dsPIC33EPXXXGS70X/80X Family Silicon Errata and Data Sheet Clarification

The dsPIC33EPXXXGS70X/80X family devices that you have received conform functionally to the current Device Data Sheet (DS70005258C), except for the anomalies described in this document.

Data Sheet Clarifications

FIGURE 4-2: PROGRAM MEMORY MAP FOR dsPIC33EP128GS70X/80X DEVICES

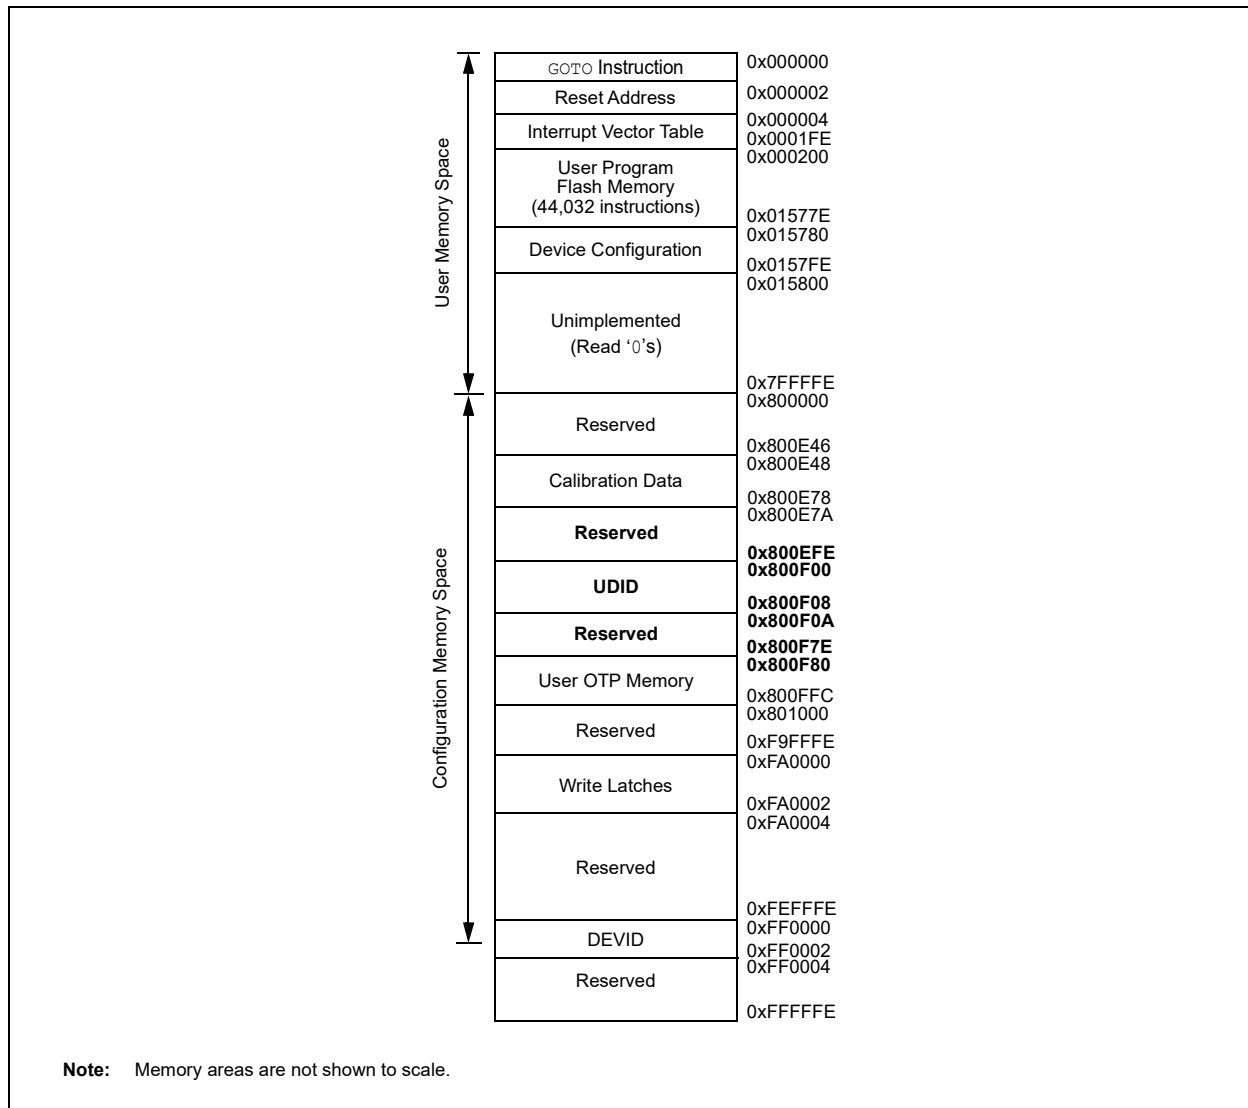
In Figure 4-2, the following changes have been made as shown in **bold**:
